SIB 64 01 26

RECALL 26V-096: CHECK AND REROUTE COCKPIT WIRING HARNESS

2026-04-13

This Service Information Bulletin (Revision 4) replaces SI B64 01 26 **dated March 2026**.

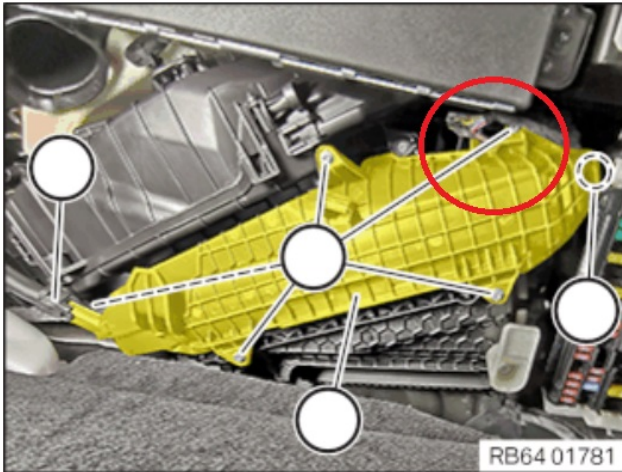
Use caution when re-installing the plastic cover for the cabin air filter to ensure no damage is done to the vehicle's wiring harness.

Inspect the harness routing, and add a retainer to the harness (arrow) to prevent it being pinched under the air filter plastic cover.

Check the vehicle wiring harness routing (circled) to ensure it is not pinched by the plastic cover over the filter.

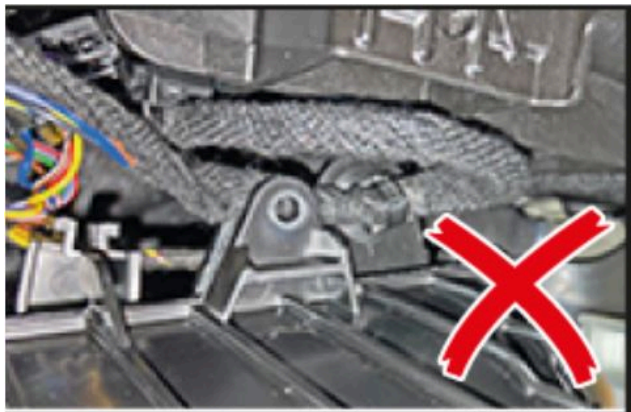
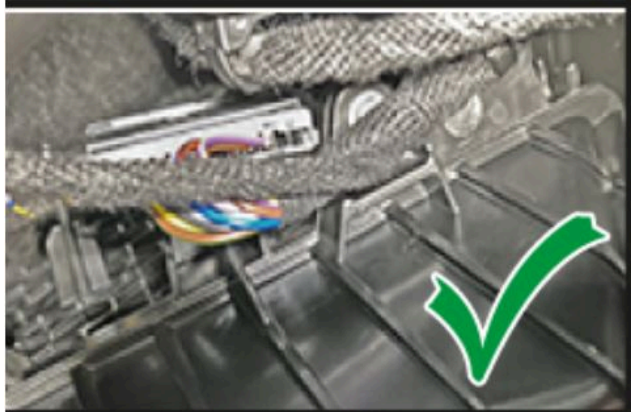
This is where the harness can be damaged when installing the cabin air filter cover screw.

This shows the harness damage; the sheathing has been abraded.

With the harness pulled out of the way, you can see the screw mounting hole for the cabin air filter cover.

The upper photo has the harness visible through the mounting hole. This positioning is not acceptable- the harness must be moved out of the way of the mounting screw.

The lower photo shows the harness positioned in front of the mounting screw, which is an acceptable routing.

Double check the routing of the harness prior to installing the screws for the cabin air filter cover.

If the wiring harness has already been damaged during the installation of the cabin air filter cover, the damaged section of the wiring harness must be repaired.

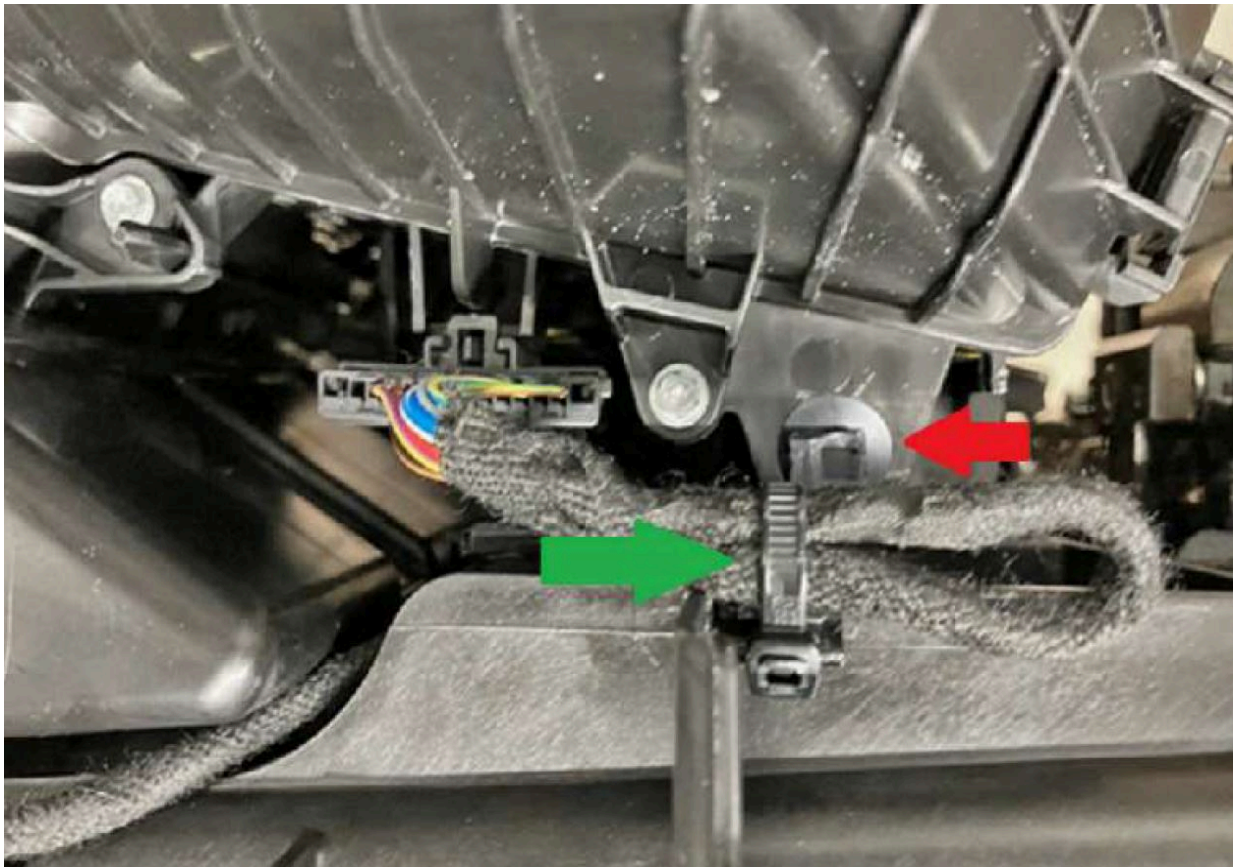
The original harness retainer must be disconnected. This is shown by the red arrow below. It can be left clipped into vehicle but must be disconnected from harness for strain relief.

Install a new harness retainer with cable strap on the instrument panel wiring harness, see green arrow.

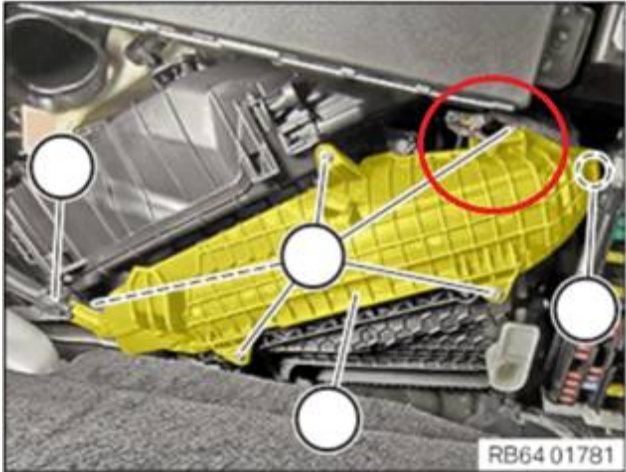
Use caution when re-installing the plastic cover for the cabin air filter to ensure no damage is done to the vehicle's wiring harness.

Inspect the harness routing and add a retainer to the harness (arrow) to prevent it being pinched under the air filter plastic cover.

Check the vehicle wiring harness routing (circled) to ensure it is not pinched by the plastic cover over the filter.

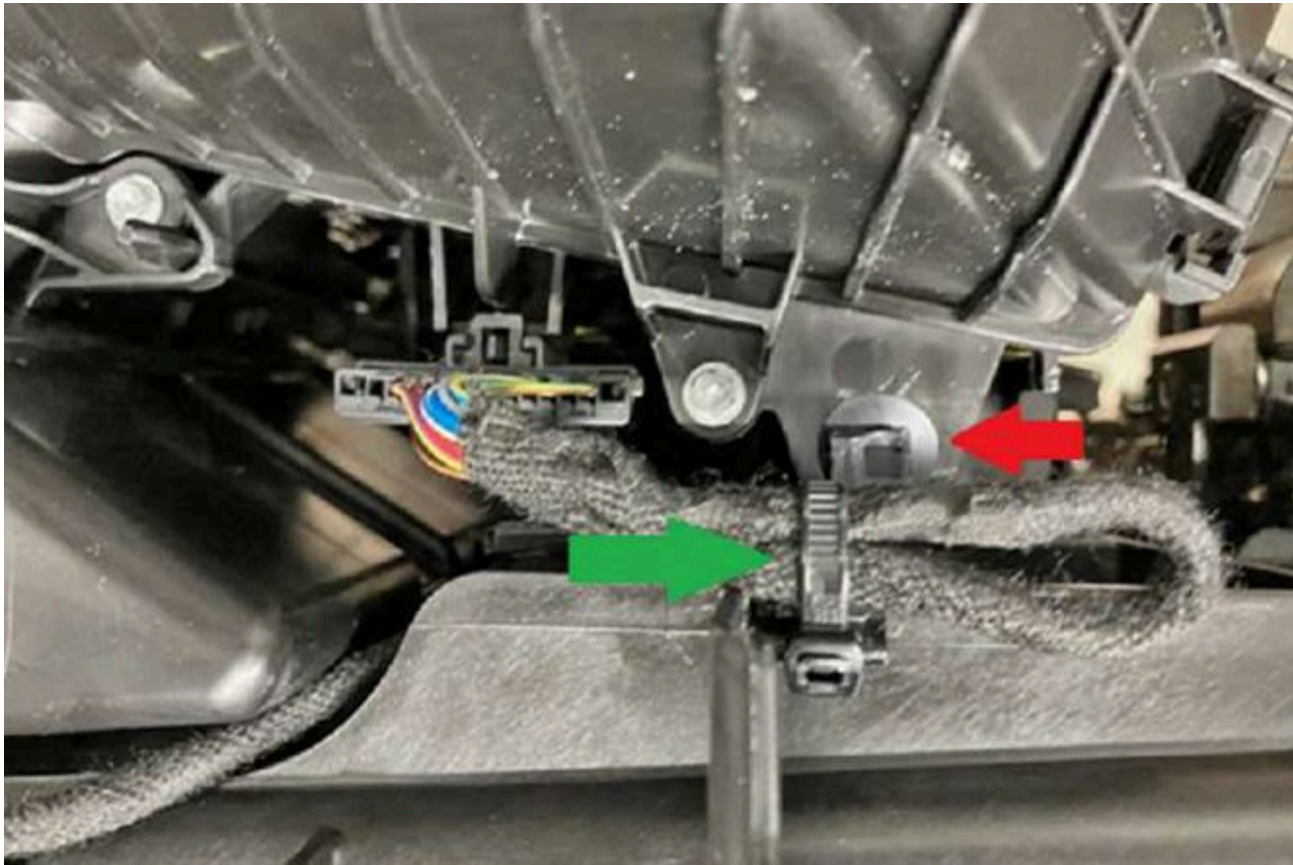
The original harness retainer must be disconnected. This is shown by the red arrow below. It can be left clipped into vehicle but must be disconnected from harness for strain relief. Install a new harness retainer with cable strap on the instrument panel wiring harness, see green arrow.
